**Joint Petition for a Contested Case Hearing
Regarding Poly Met Mining, Inc.'s
Permit to Mine Application
For the NorthMet Project**

Submitted to the Minnesota Department of Natural Resources

February 28, 2018

Figure 1: Reproduction of graph from Updated NI 43-101 Technical Report on the NorthMet Deposit, Appendix G, January 14, 2013.

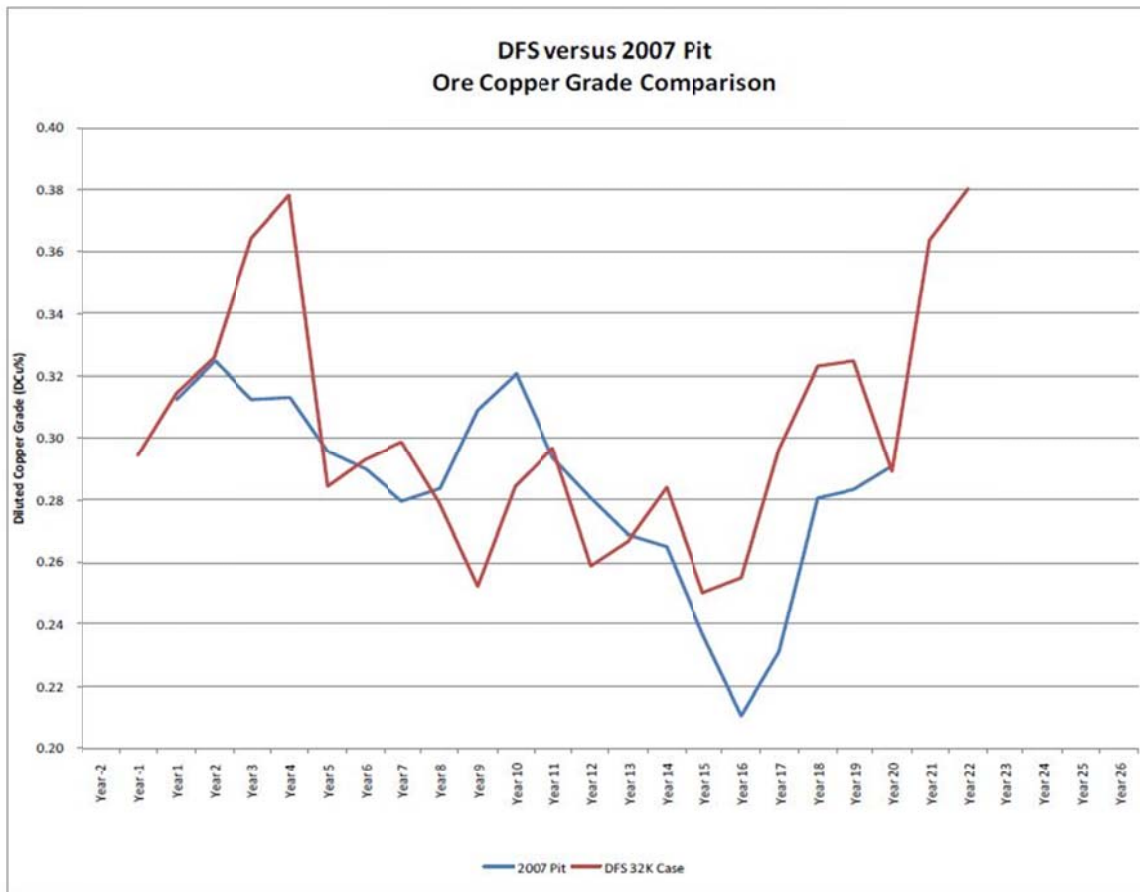
A detailed look at the revenue projections is nothing short of shocking, making it clear that the trust fund contributions are strictly a matter of faith. In Mine Year 9, for instance, 72% of the Applicant’s projected income will be dedicated to financial assurance costs, primarily in the form of the ramped up trust fund contributions.²⁴⁶ Petitioners find it simply unbelievable to presume that the Applicant will be contributing 72% of their income into a trust fund for the benefit of the state. In Mine Year 15, the Applicant is projected to be *cash flow negative*: the Applicant will not produce enough revenue to pay for its financial assurance obligations.²⁴⁷
